APP-GW-GLR-079-NS, Revision 0

“AP1000 Verification of Water Sources for Long-Term Recirculation Cooling Following a LOCA”

Technical Report 26

DCD Markup

DCD Figure 2.2.3-1 (Sheet 2 of 2)
 Passive Core Cooling System

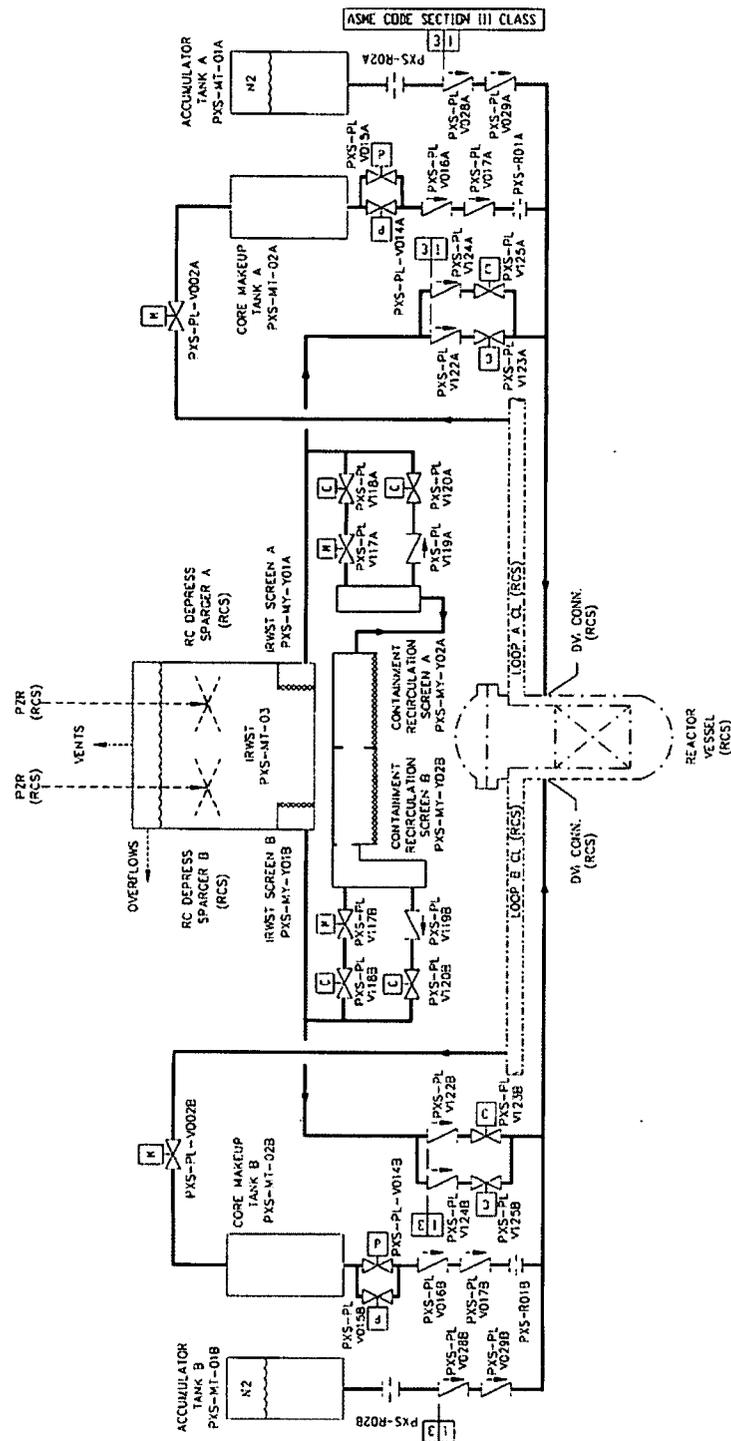
Current DCD Figure Showing Area to be Revised

Revised DCD Figure

Figure 1.2-9
**Nuclear Island General Arrangement
Plan at Elevation 117'-6" with Equipment**

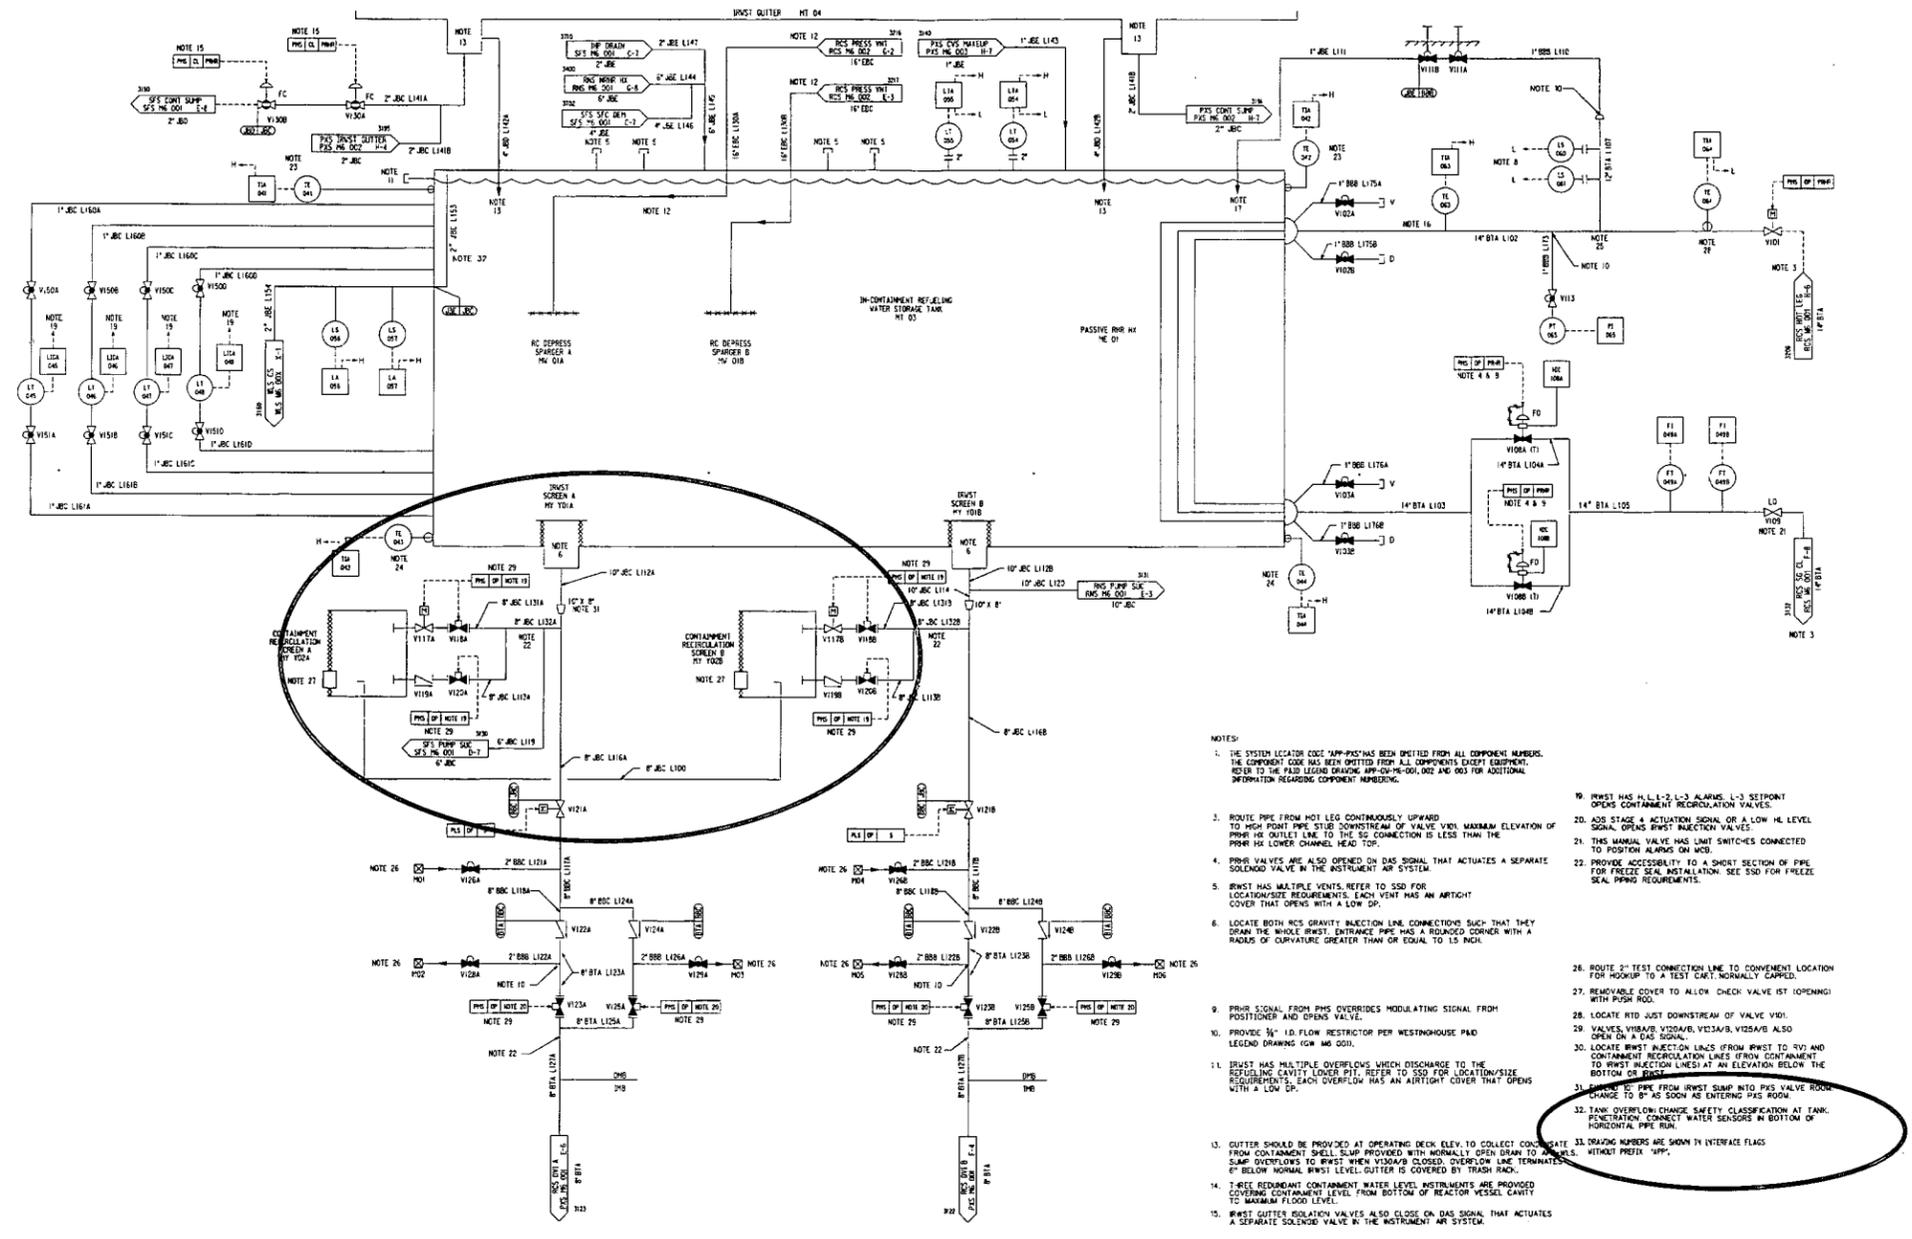
Revised DCD Figure

Figure 6.3-2
Passive Core Cooling System
Piping and Instrumentation Diagram (Sheet 2)

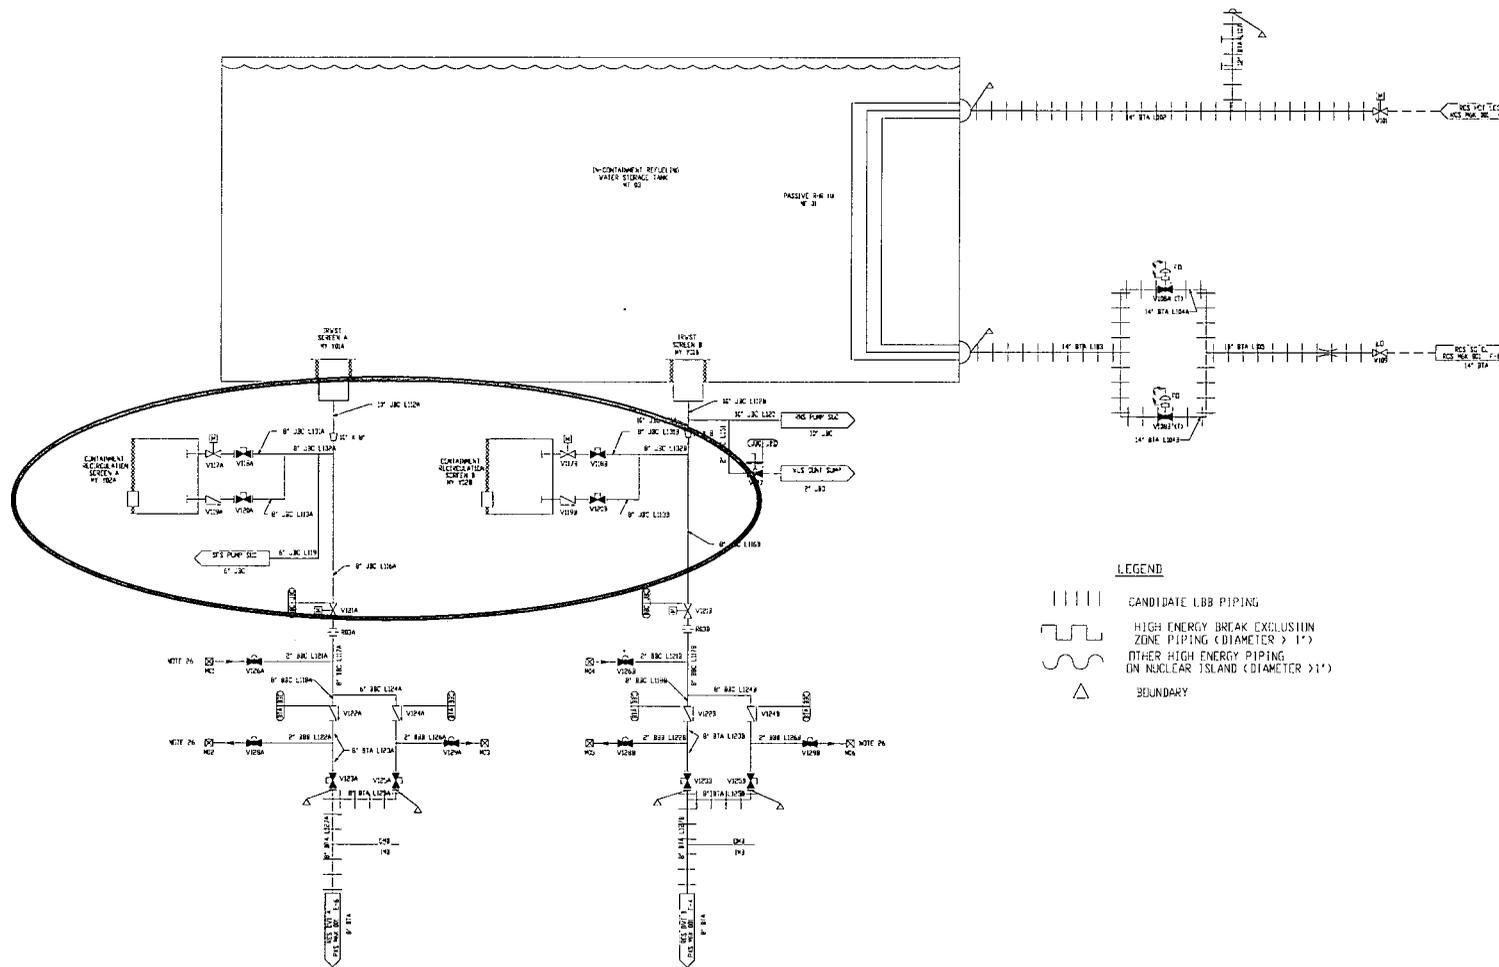
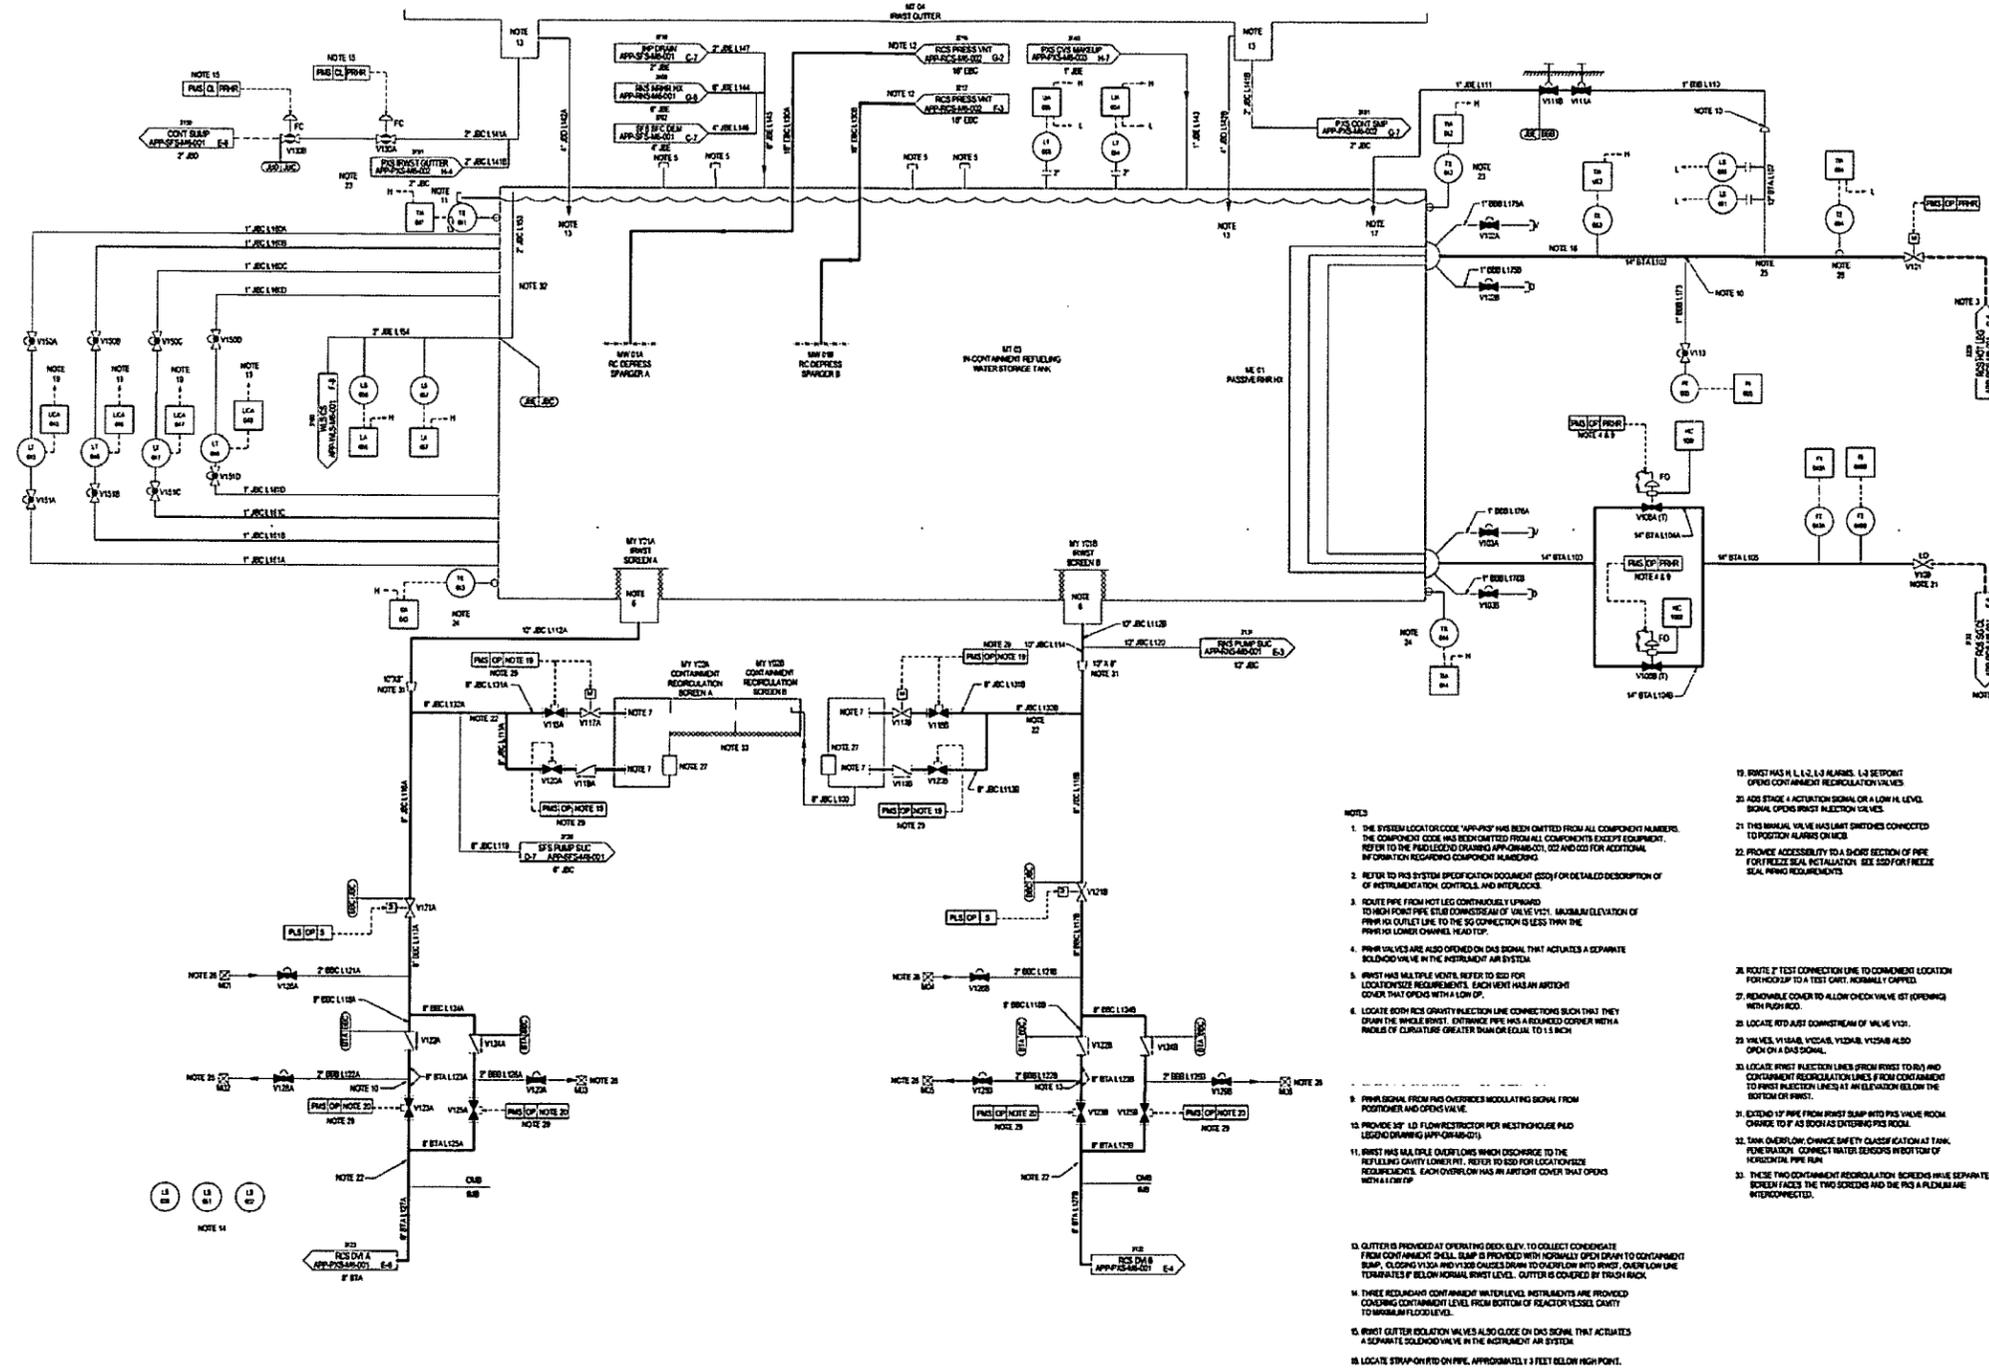
Current DCD Figure Showing Areas to be Revised

Modifications in indicated area same as modifications to Figure 6.3-2

Revised DCD Figure

Figure 9A-1 (Sheet 4 of 16)

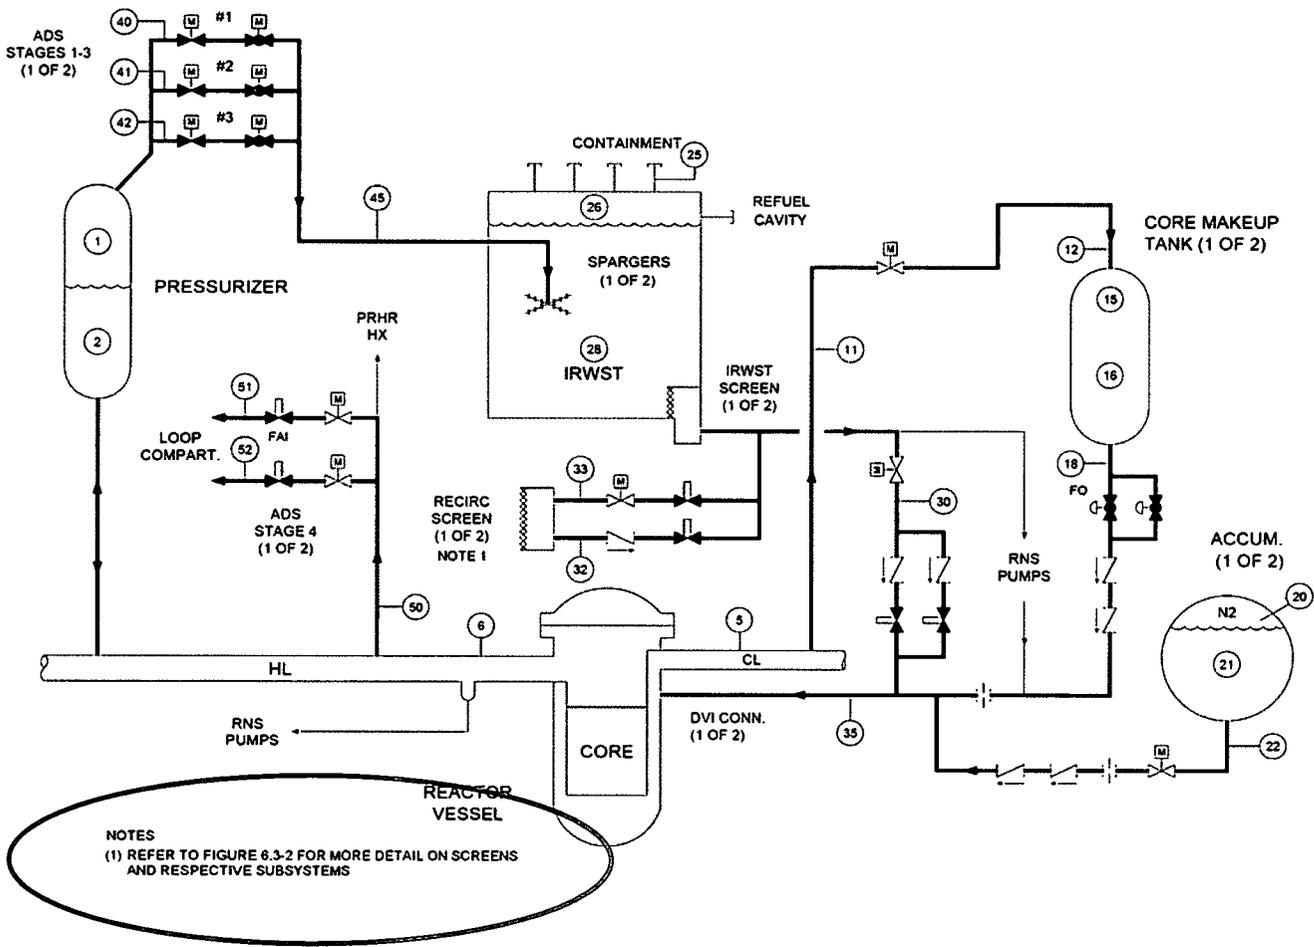
Current DCD Figure Showing Area to be Revised
